UNITED STATES PATENT AND TRADEMARK OFFICE

APPLICATION NO.	FILING DATE	FIRST NAMED INVENTOR	ATTORNEY DOCKET NO.	CONFIRMATION NO.
10/767,803	01/29/2004	Robert I. Paterson	04-027	5564

Office Action Summary	Application No. 10/767,803	Applicant(s) PATERSON ET AL.	
	Examiner Mark R. Wendell	Art Unit 3609

DETAILED ACTION

Figure 1 of Hohmann

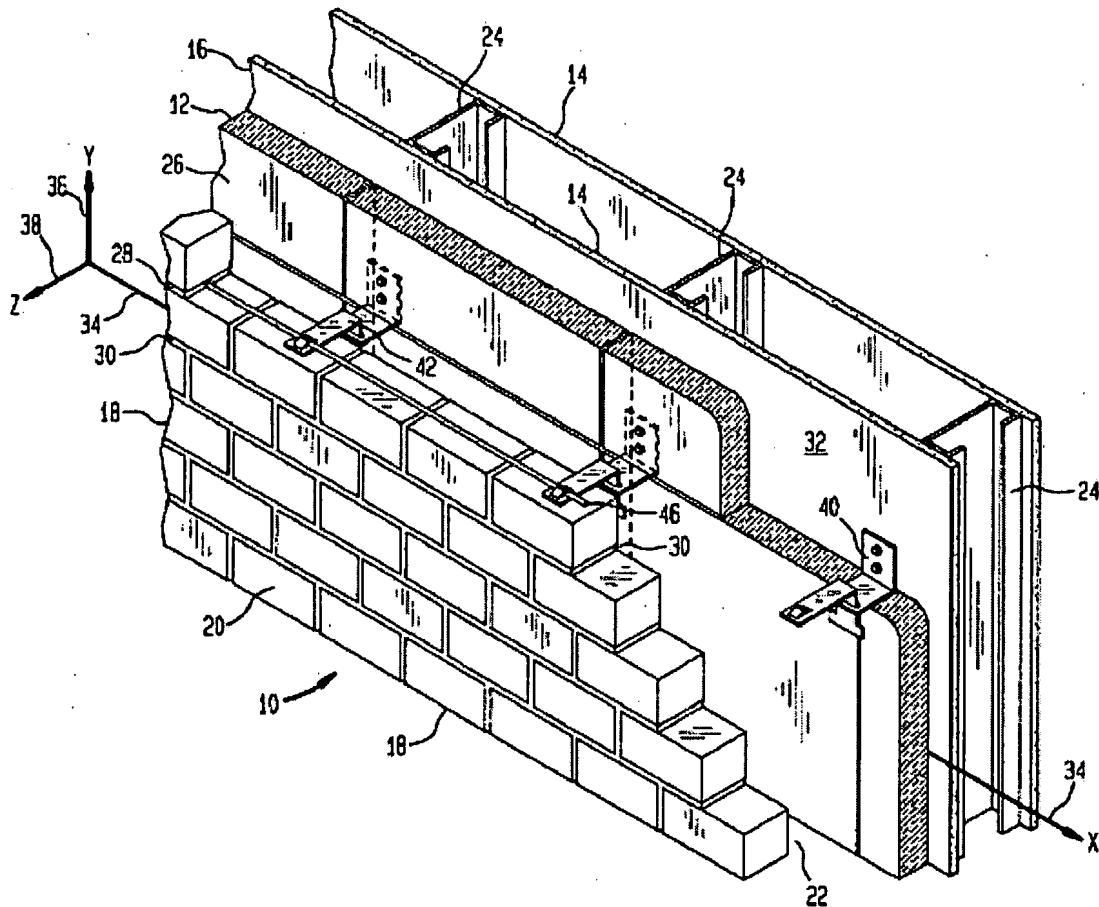
Claims 28-32, 35 are rejected under 35 U.S.C. 102(b) as being anticipated by Hohmann (US 5816008). Hohmann illustrates in Figures 1 and 2 a system for reinforcing or fixing a veneer wall comprising:

- A fastener (48, 52) installed into the back-up wall (26) of a structure, the fastener having a threaded portion extending at right angles to the back-up wall providing engagement with a connector (42);
- A connector (42) fitted onto the fastener (48, 52) and having a portion for receiving (66, 68) a reinforcement wire (46);
- A reinforcement wire (46) fitted into the connector (42);
- A connector (42), reinforcement wire (46) and a portion of the fastener (48, 52) encased in filler material (column 4, lines 62-65) within the bed joint (28) of the veneer wall (10).

Regarding claim 31, Hohmann illustrates in Figure 1 a reinforcement wire (46) threaded through receiving portions (66,68) of multiple connectors (42) along the mortar bed joint (28).

Hohmann illustrates in Figures 1 and 2:

- A connector (42) fitted onto the fastener (48, 52) and having a portion for receiving (66, 68) a reinforcement wire (46);
- A twisted profile reinforcement wire (46) fitted into the connector (42);
- A connector (42), reinforcement wire (46) and a portion of the fastener (48, 52) encased in filler material (column 4, lines 62-65) within the bed joint (28) of the veneer wall (10).

Regarding claim 7, Hohmann illustrates in Figure 1, the reinforcement wire (46) positioned close (between 25-50 mm) from the external surface of the veneer wall (10). Hohmann discloses the invention except for the reinforcement wire positioned 25-50mm from the external surface of the wall. It would have been obvious to one having ordinary skill in the art at the time the invention was made to have a reinforcement wire

Regarding claim 9, Hohmann illustrates in Figure 1 a reinforcement wire (46) threaded through receiving portions (66,68) of multiple connectors (42) along the mortar bed joint (28).

Regarding claims 14, 15 and 34, Hohmann illustrates in Figure 1 a reinforcement wire (46) extending the length of the wall and around a building.

Figure 2 of Hohmann

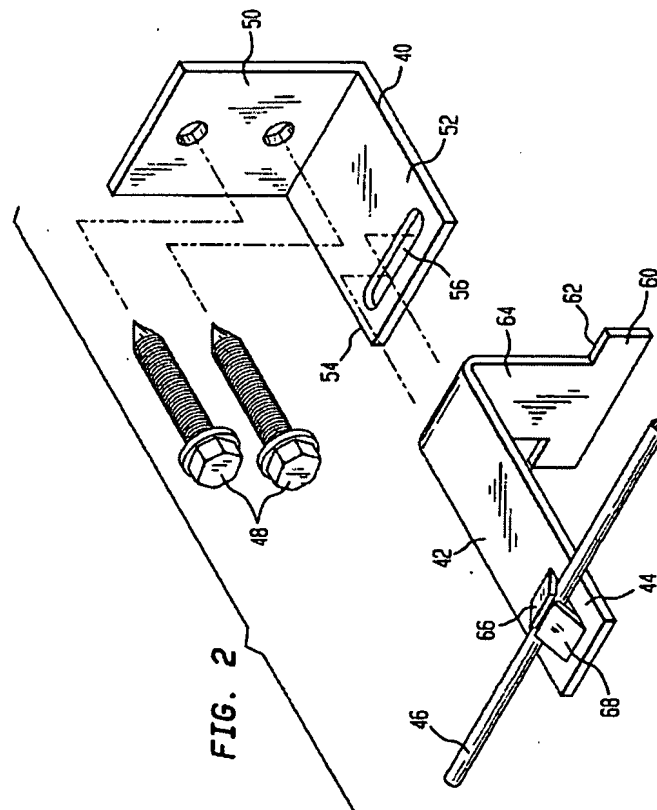
Regarding claim 8, Hohmann illustrates in Figures 1 and 2 a reinforcement wire (46) threaded through a hole in the receiving portion (66,68) of the connector (42).

Cooney does not teach a hole passing through opposing sides of the connector to facilitate the use of a reinforcement wire. However, Hohmann illustrates in Figures 1 and 2 a hole passing through opposing sides of the connector (42) at right angles to the longitudinal axis of the tube, or bracket (64). It would be obvious to one of ordinary skill in the art to modify the reinforcing bracket connectors of Hohmann with the thread engaging fastener / connector of Cooney for cost and ease purposes. Threaded connector / fastener systems are less costly and more readily available than large, cumbersome bracketing fasteners. It would also be obvious to one ordinary skill in the art to provide a hole within the connector of Cooney as shown in the bracket of Hohmann to run electrical / cable wires within the veneer wall within the building.

- A connector, or bracket (42), having a holes defined by (66, 68) for receiving a reinforcement wire (46) at a right angle to the wall tie (50);
- Securing the reinforcement wire and connector in a filler material within the bed joint (28) of the veneer wall (10).

Figures 2 and 3 of Cooney et al.

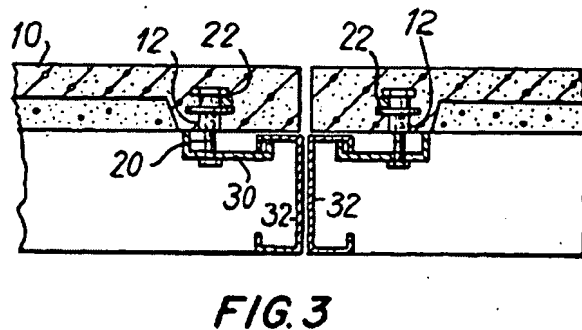
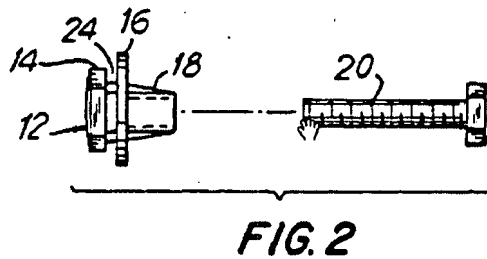
Claim 35 is rejected under 35 U.S.C. 102(b) as being anticipated by Cooney et al. (US 5138813). Cooney illustrates in Figure 2 a metal wall tie fastener (20) made from twisted profile wire and having helical fins. The examiner notes that Cooney discloses item (20) as being a "securing bolt" and it is well known in the art of building construction that bolts have helical fins and can be installed into walls using a percussion tool without the use of an adhesive. The examiner also notes that the fastener being installed using a percussion tool adds no additional structure to the claim.

Hohmann does not illustrate a fastener in combination with a thread engaging connector. However, Cooney illustrates in Figure 2:

- A fastener (20) capable of being fastened to a back-up wall having a threaded portion that extends at right angles to provide a thread engagement with a connector (12);

Regarding claim 2, Cooney illustrates in Figure 2 a metal wall tie fastener (20) of a helical type.

Regarding claims 4 and 5, Cooney illustrates in Figure 3 the fastener (20) extending at a right angle to the plane of the back-up wall and the connector (12) fitting over the protruding end of the fastener (20).

Regarding claim 19, Cooney illustrates in Figure 2 a connector (12) comprising:

- A tube of internal diameter between 6 and 12 mm (18) closely fitting the external diameter of the helical fins of the wall tie (20). The examiner notes it is well known within the art of building construction that bolts typically have diameters between 3 and 15 mm, thus a connector to fit a bolt of that range would have to be between 6 and 12 mm;
- At least one region of narrowed internal diameter (18, 24) and crimped section to prevent withdrawal of the wall tie (20) from the connector (12).

- A helical wall tie (20) fastened into the inner leaf of a wall secured through mechanical interlock without an adhesive.
- A connector (12) over the wall tie (20), the connector (12) having a narrowed diameter (18) defined by opposed flats.

Figure 1 of Hohmann

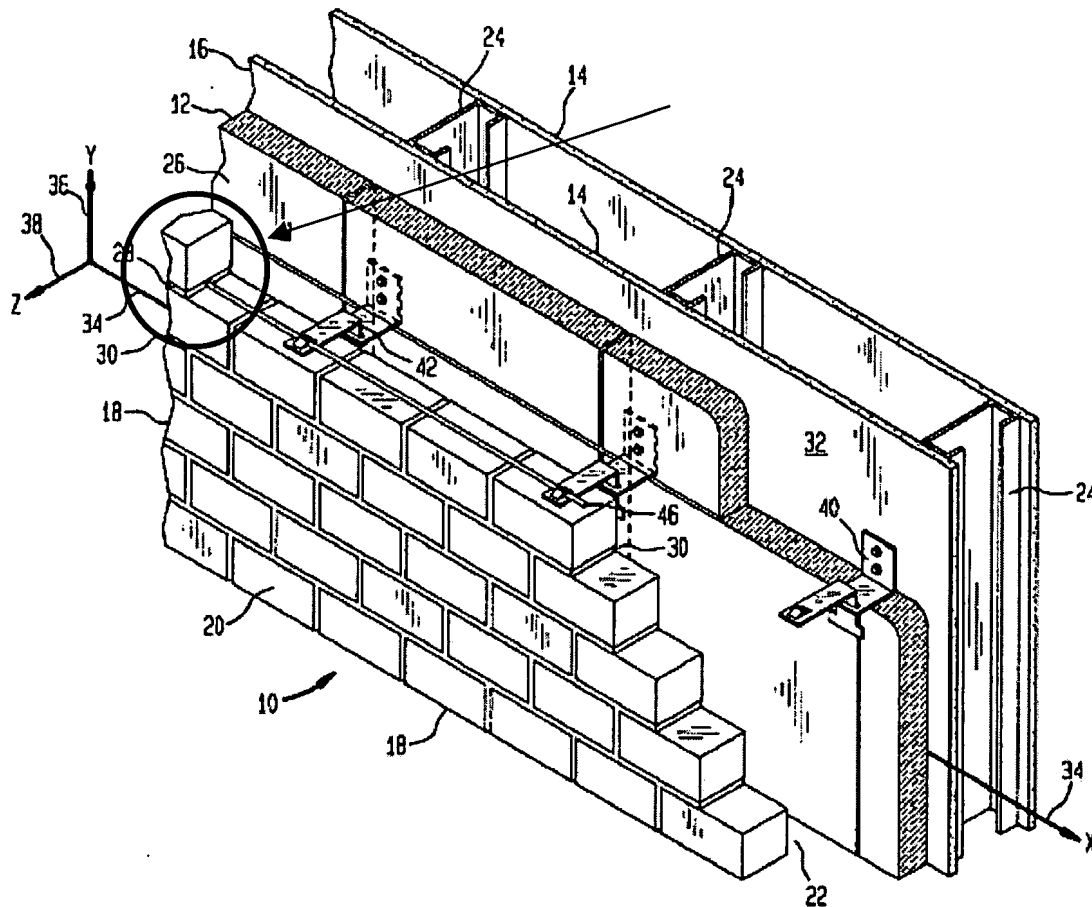
Regarding claims 16 and 17, Hohmann illustrates in Figure 1 the connector (42) and reinforcement wire (46) within a mortar bed joint (28) at a junction of a pair of bricks (see modified figure below).
